July 15, 2009

UN#09-320

Subject: UniStar Nuclear Energy, NRC Docket No. 52-016
Response to Request for Additional Information for the
Calvert Cliffs Nuclear Power Plant, Unit 3,
RAI No. 58, Seismic Design Parameters,
RAI No. 63, Seismic Subsystem Analysis, and
RAI No. 65, Seismic System Analysis

**Response to NRC Request for Additional Information,
RAI No. 58, Seismic Design Parameters, Question 03.07.01-2 and 03.07.01-4;
RAI No. 63, Seismic Subsystem Analysis, Question 03.07.03-01; and
RAI No. 65, Seismic System Analysis; Question 03.07.02-15;
Calvert Cliffs Nuclear Power Plant Unit 3**

Figure 1: Comparison of Calvert Cliffs Site SSE 5% damping spectrum, RG 1.60 spectrum scaled to 0.1g and GMRS for NI structures

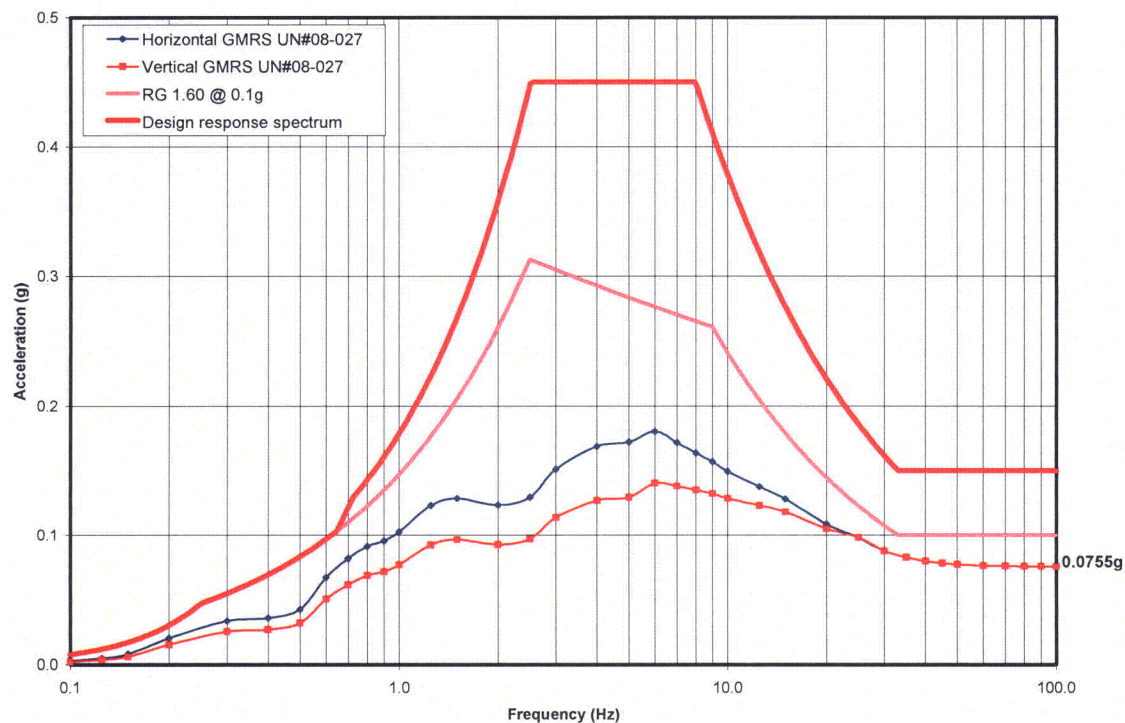
In FSAR Section 3.7.1.1.1, on page 3.0-32, it discusses the design response spectrum used to analyze the Ultimate Heat Sink (UHS) Makeup Water Intake Structure. The spectral comparison between the European Utility Requirements (EUR) soft soil spectrum scaled to 0.15 g, the RG 1.60 spectrum scaled to 0.1 g, and the ground motion response spectra (GMRS) shown in Fig. 3.7-38 indicates that the RG 1.60 spectrum and GMRS exceed the EUR spectrum at frequencies below 0.7 and 0.4, respectively. What is the corresponding comparison of displacements and velocities for these spectrum motions, and if the EUR displacements are exceeded, how will this be addressed in the design of piping and other appurtenances connected to these buildings including the design of buried utilities?

Revision 5 of the FSAR, Figure 3.7-38, provides comparison of EUR soft soil spectrum scaled to 0.15 g with RG 1.60 spectrum scaled to 0.1g and site-specific horizontal GMRS (with PGA of 0.067 g). As described in FSAR Section 3.7.1.1.1, the scaled down EUR soft spectrum was selected as design response spectrum for the UHS Makeup Water Intake Structure (MWIS). Due to the unavailability of FIRS and other sub-surface investigation information, the GMRS at the bottom of Nuclear Island, NI, (approximate Elevation 44 ft) was considered conservative representation of FIRS at the bottom of UHS MWIS. The comparison with RG 1.60 spectrum was provided as additional information. A discussion is also presented in Section 3.7.2.4 to assess and address impact of exceedance of the design response spectrum by the representative FIRS (same as GMRS at NI) in the low frequency region.

However, as discussed during the NRC onsite technical audit (March 17 through 19, 2009) and NRC public meeting (April 17, 2009), the EUR soft soil spectrum scaled to 0.15g will be enriched in the low frequency region to envelop RG 1.60 spectrum scaled to 0.1g and the representative FIRS (GMRS underneath NI). The horizontal and vertical GMRS for NI were updated to a PGA of 0.0755 g as reported in Table 2.5-22 and Figure 2.5-87 of enclosure to Unistar Nuclear Energy letter UN#08-027¹.

Figure 1 in this response depicts the updated design response spectrum for UHS MWIS. The modified design response spectrum envelops the RG 1.60 spectrum scaled to 0.1g and representative FIRS (new GMRS with PGA of 0.0755 g for NI submitted in Unistar Nuclear Energy letter UN#08-027¹). Therefore, the displacement and velocity spectra for these motions (i.e., RG 1.60 and GMRS for NI) will also be enveloped by those for the updated design response spectrum.

Once the sub-surface investigation at the location of the UHS MWIS is complete, it will be demonstrated that the actual FIRS for the UHS MWIS are enveloped by the design response

spectrum. As a result, no special assumptions or design procedures are required for the design of piping and other appurtenances connected to UHS MWIS.

Figure 1: UHS MWIS Geometry (internal walls and openings not shown for clarity)

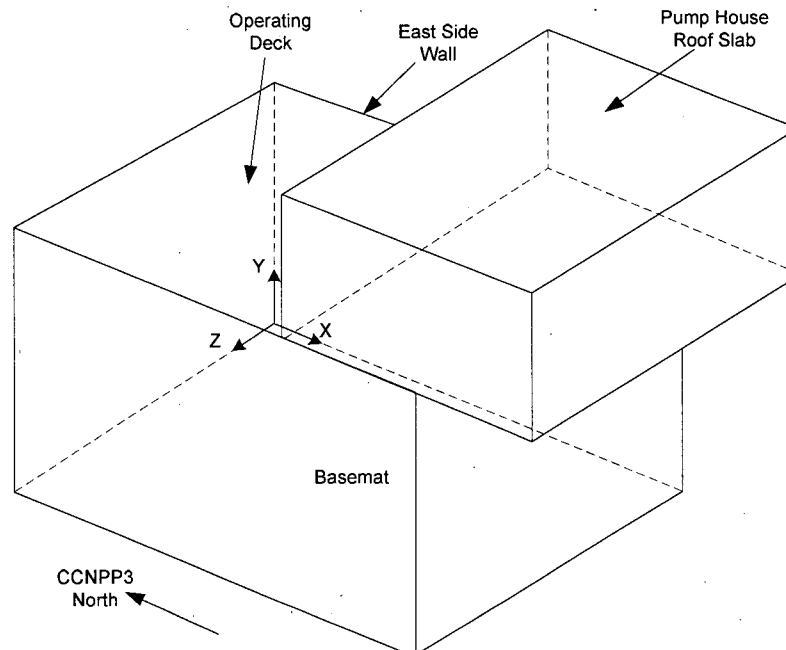
In FSAR Section 3.7.2.6 on page 3.0-40, it states that for the Ultimate Heat Sink (UHS) Makeup Water Intake Structure (MWIS), three statistically independent time histories are applied for each of the six soil cases to determine accelerations at select locations. Describe how the accelerations obtained from this dynamic analysis are applied to the static model to obtain forces and moments for structural design and provide examples of how the three components of earthquake motion are combined and compare the results to those of the 100-40-40 rule presented in RG 1.92, Revision 2. The use of an equivalent static approach to determine forces and moments in the structure may not be conservative as dynamically computed forces and moments will retain the appropriate sign from the analysis and the static approach will not. How will this be addressed in the development of loads used in the design of the structure?

Describe how the accelerations obtained from the dynamic analysis are applied to the static model:

Figure 1 shows the geometry of the Ultimate Heat Sink (UHS) Makeup Water Intake Structure (MWIS), including the X, Y and Z coordinate axes from the GT STRUDL model.

As described in FSAR Section 3.7.2.6, the time history analysis of UHS MWIS is performed for statistically independent time histories in the three directions for six soil cases. For a structural panel (wall/slab) under consideration, the three components of maximum acceleration response (i.e., absolute peak values from acceleration response time history) are determined at each joint of GT STRUDL finite element model for each soil case and in each direction of earthquake, resulting in a total of 54 acceleration values (i.e., 6 soil

Figure 5: Typical 100-40-40 Co-directional Seismic Combination for Operating Deck

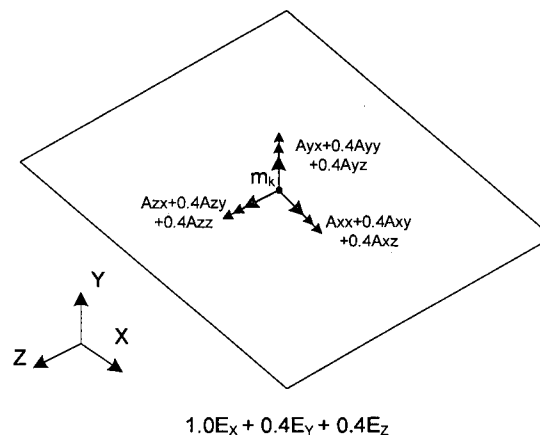
Provide examples of how the three components of earthquake motion are combined, and compare the results to those of the 100-40-40 rule presented in RG 1.92, Revision 2:

The co-directional response combination is performed using the 100-40-40 rule described in ASCE 4-98, such that when 100% SSE is applied in one direction, 40% SSE is applied in the other two directions. As shown in Equation (2), the co-directional response combination results in twenty four (24) load combinations, including variations in signs (plus or minus) of the applicable seismic force components.

The above methodology is the same as that presented in Regulatory Position C.2 of RG 1.92, Revision 2. Therefore, the comparison of responses mentioned in the question is not presented here.
